SUBJECT: COOPER NUCLEAR STATION - AMENDMENT NO. 173 TO FACILITY
OPERATING LICENSE NO. DPR-46 (TAC NO. M92807)

AMENDMENT TO FACILITY OPERATING LICENSE

Amendment No. 173
License No. DPR-46

SAFETY EVALUATION BY THE OFFICE OF NUCLEAR REACTOR REGULATION
RELATED TO AMENDMENT NO. 173 TO FACILITY OPERATING LICENSE NO. DPR-46

FIGURE 3.4.1

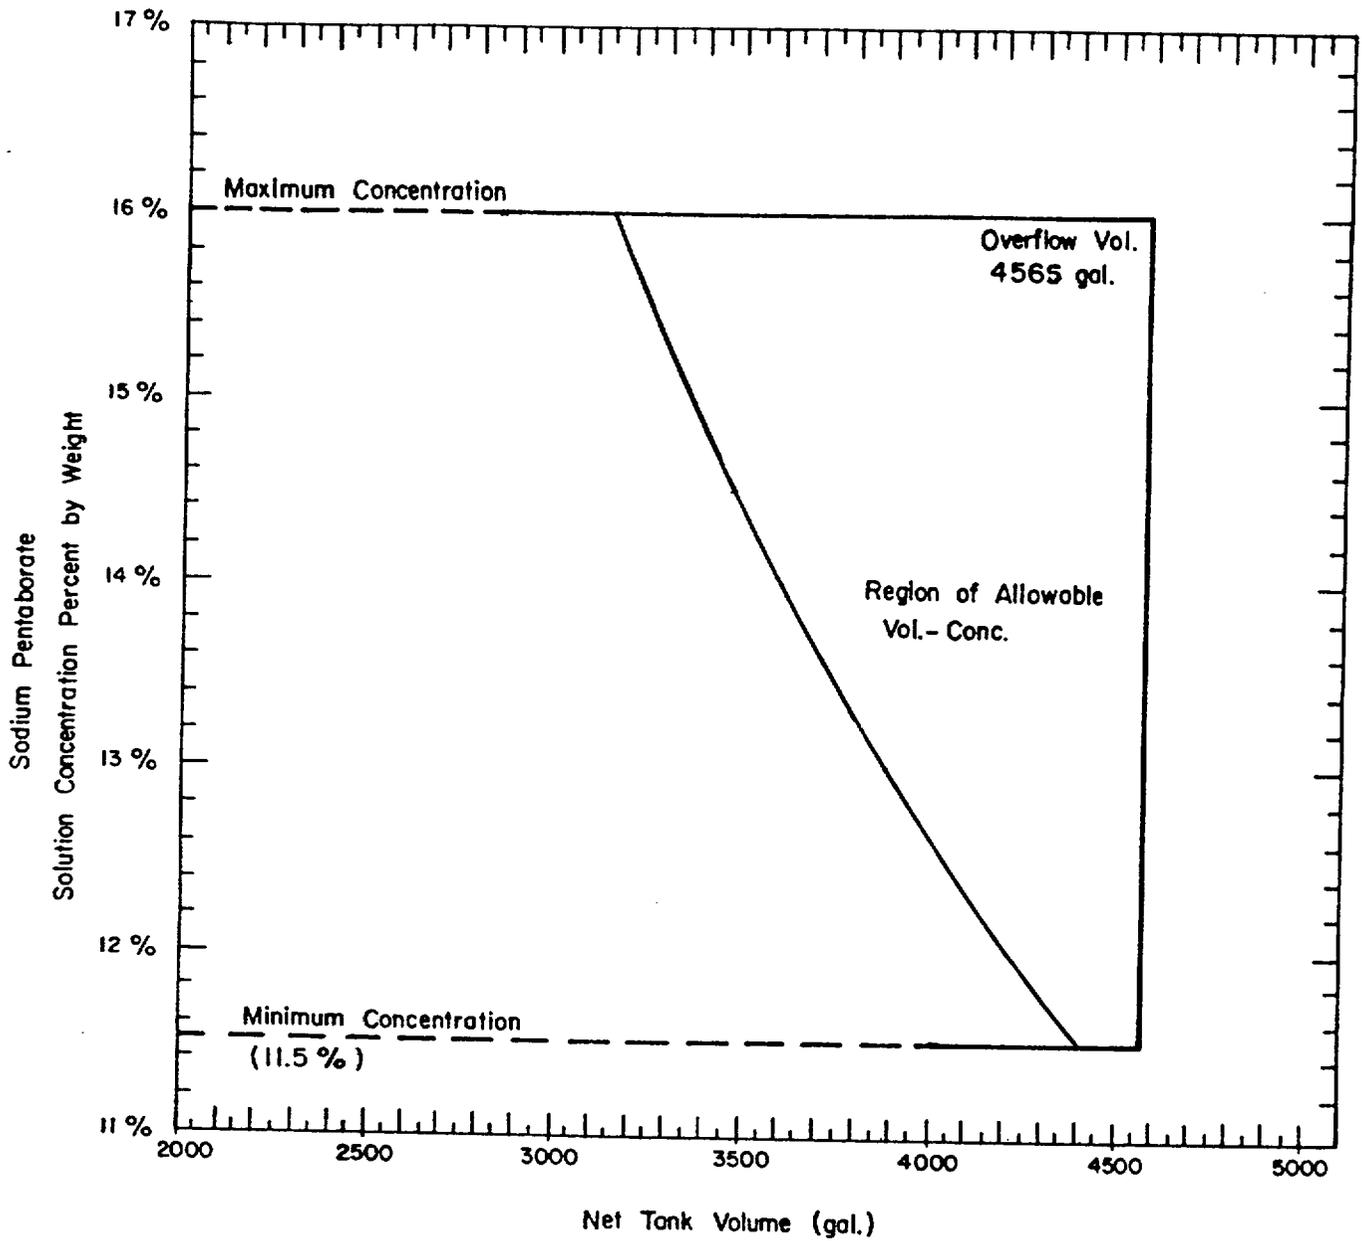
6. Figure 3.4.1, Sodium Pentaborate Solution Volume-Concentration Requirements, are revised for the increased minimum concentration required to achieve 660 ppm in the RPV. The overflow volume of the Storage Tank has also been recalculated to be 4565 gallons.

General Electric has recommended in Service Information Letter (SIL) No. 325, a concentration of 660 ppm boron as the minimum bounding concentration of natural boron in the RPV for high energy 18-month cycles and/or equilibrium fuel loadings. Therefore, to avoid having to reduce the core exposure window for future fuel cycles, CNS is proposing to raise the boron concentration in the RPV to 660 ppm from 600 ppm. TS Figure 3.4.1, Sodium Pentaborate Solution Volume-Concentration Requirements, is being revised for the increased minimum concentration required to achieve 660 ppm in the RPV. The licensee has recalculated the overflow volume of the Storage Tank to be 4565 gallons (Nuclear Engineering Design Calculation NEDC 93-142). The values of the curve in Figure 3.4.1 from 11.5 to 16 weight percent sodium pentaborate solution are:

<u>Concentration (Weight %)</u>	<u>Net Volume (Gallons)</u>
11.5	4414
12.0	4223
13.0	3887
14.0	3599
15.0	3350
16.0	3132

The proposed change to increase the required boron concentration from 600 ppm to 660 ppm ensures that a minimum 3 percent Δk xenon-free cold shutdown margin will be maintained for future core reloads, and is therefore acceptable.
